**ADDENDUM NO. 3**

Date: August 21, 2023

**Project: Project #: 0146-465  
0146-465 Isador Cohen ES / Rosemont HS Security Improvements: Group 1**

### SHEET NO.

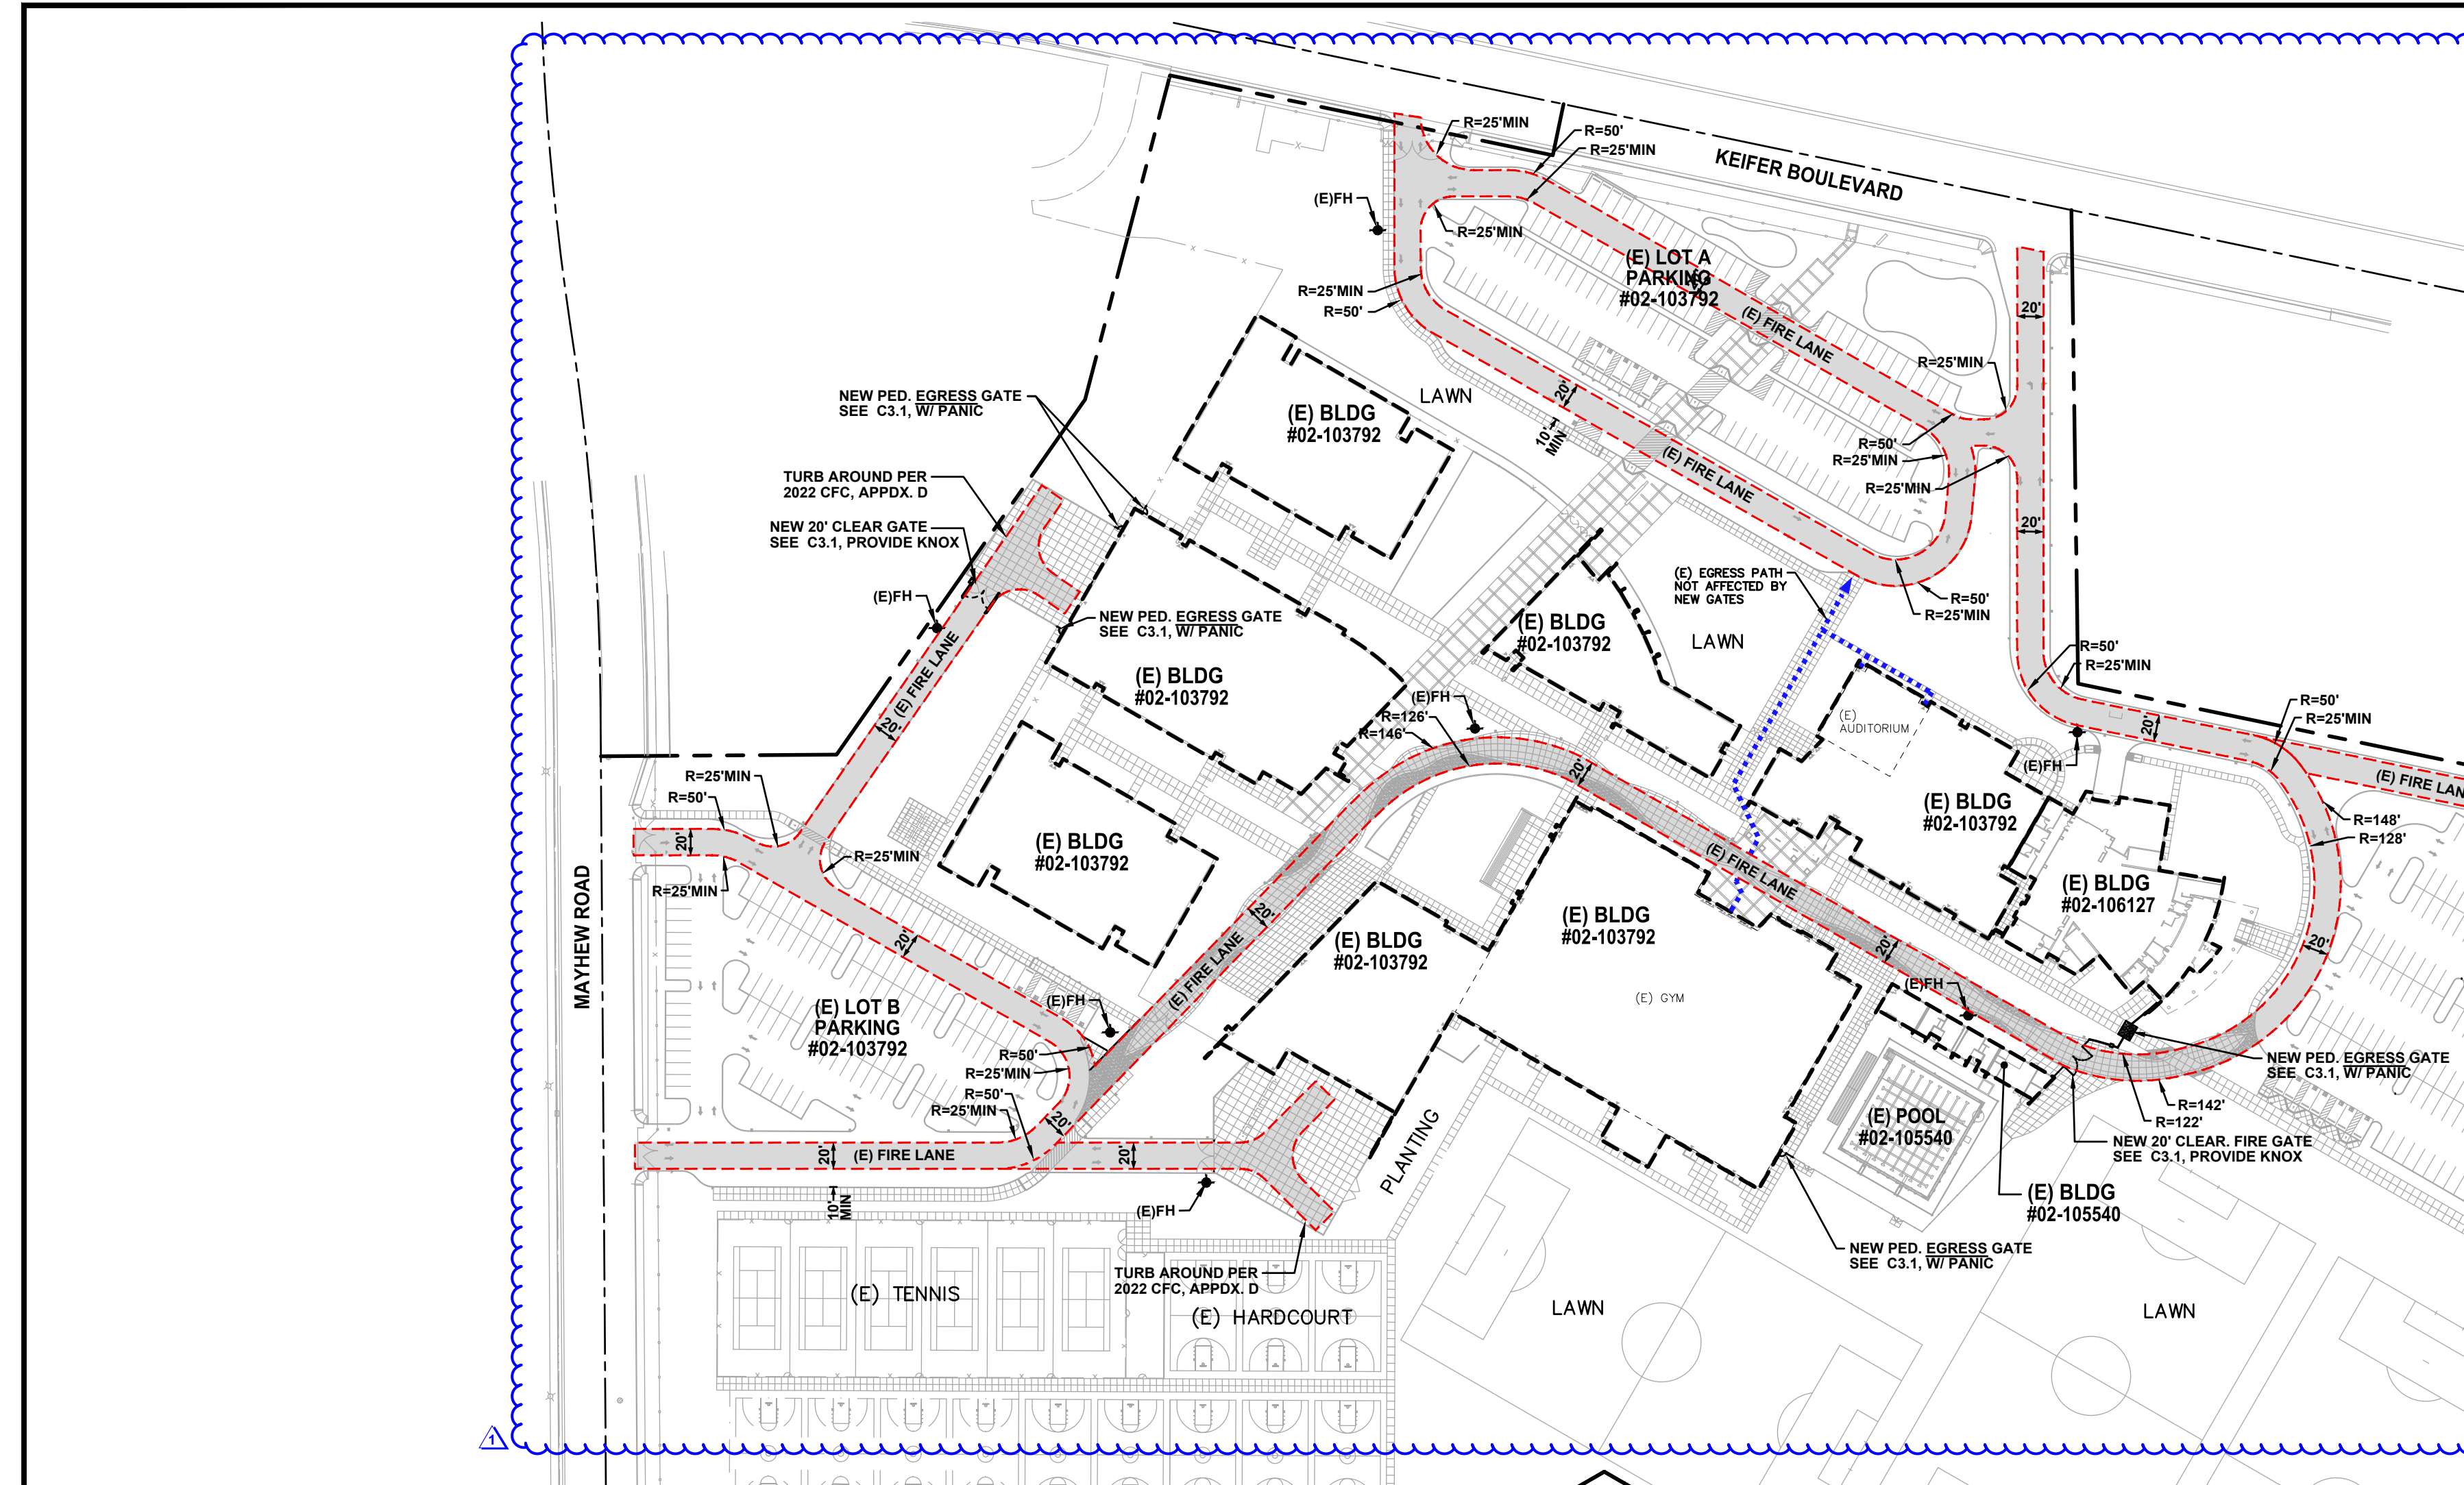
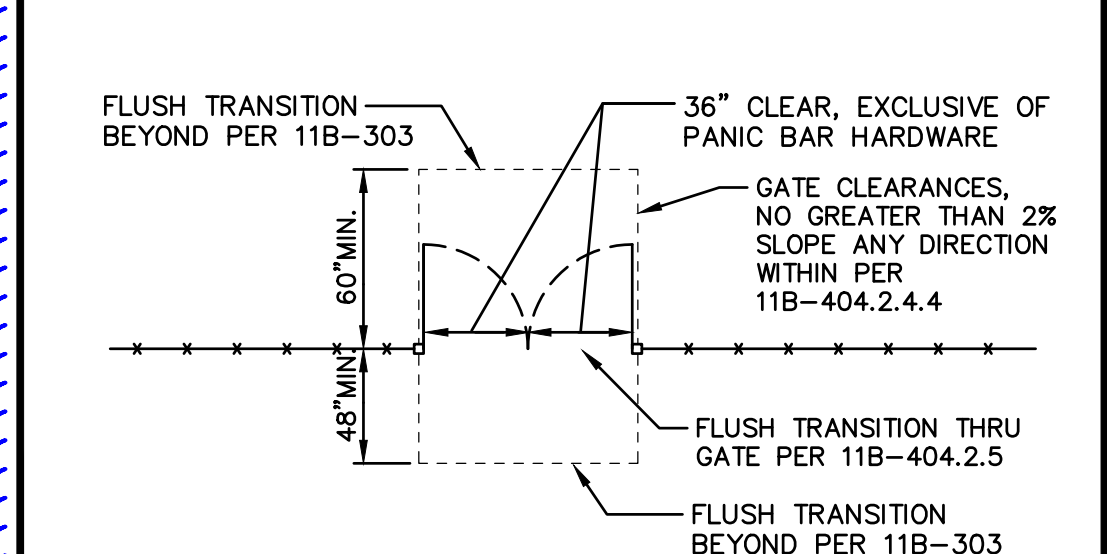
Sheet C1.0.1

- Site access plan updated with additional references.
- Gate legend added.
- General access notes added.
- Typical gate clearance details added.

SHEET NO.  
**C1.0.2**

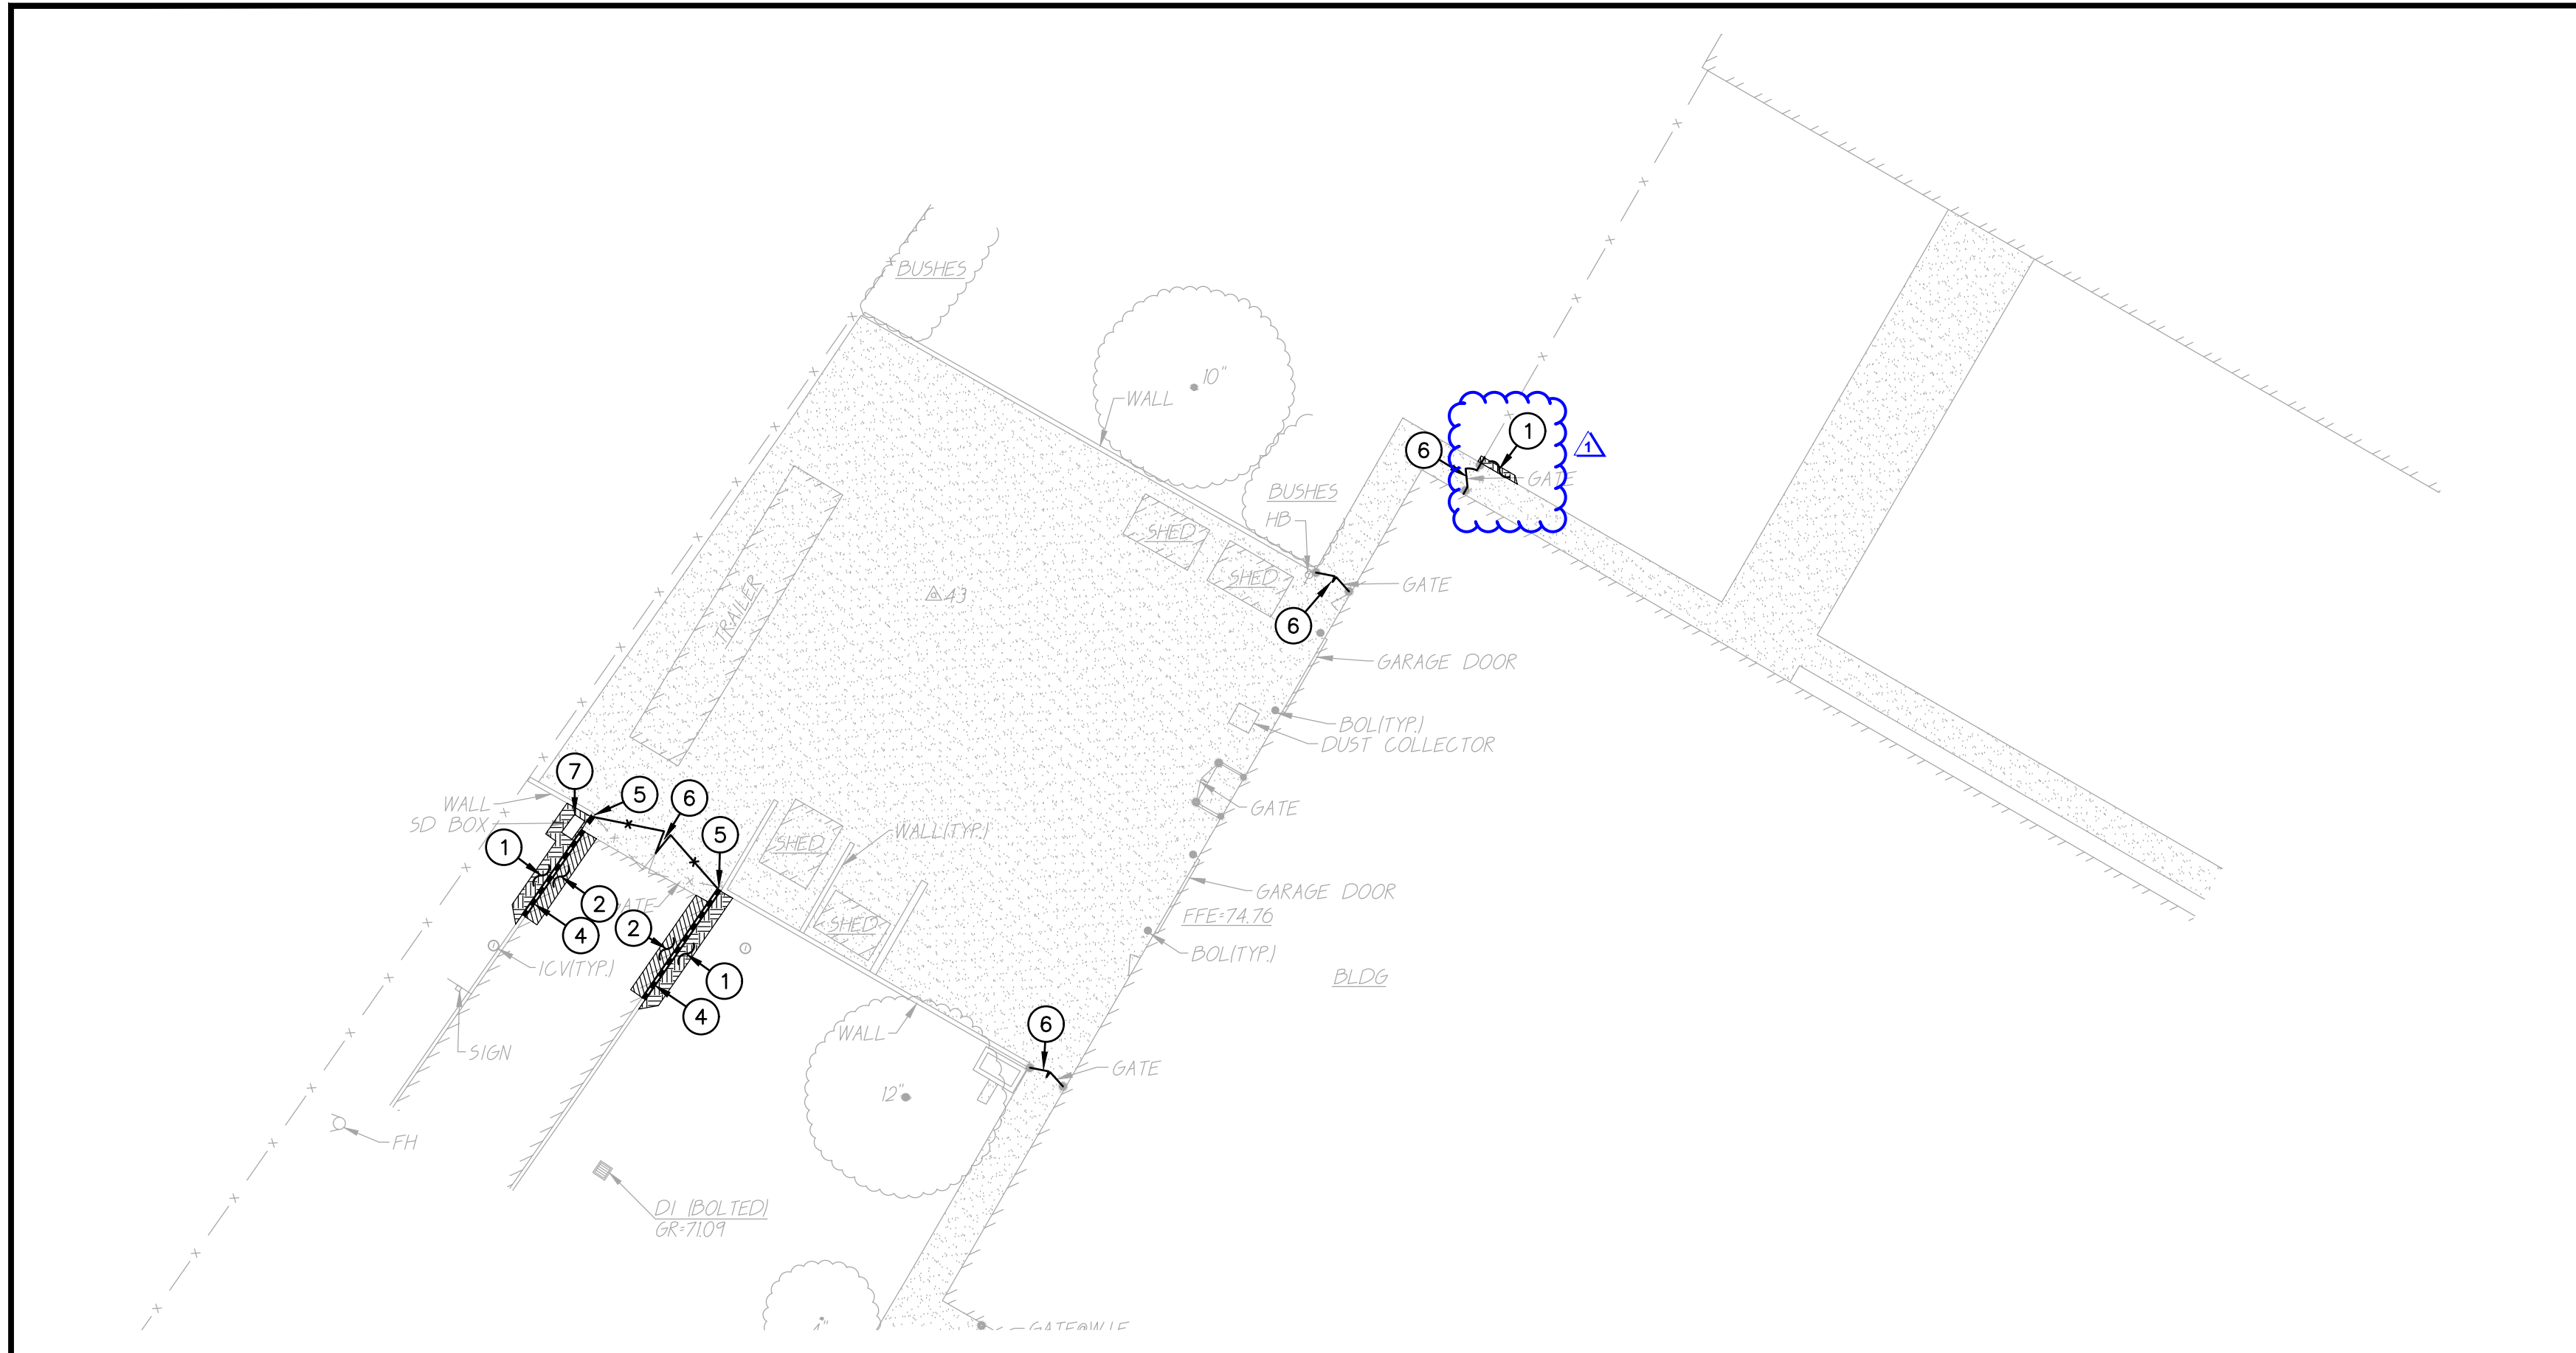
Sheet C1.0.2

- Site fire plan updated with additional references.
- Multi-purpose egress analysis provided.
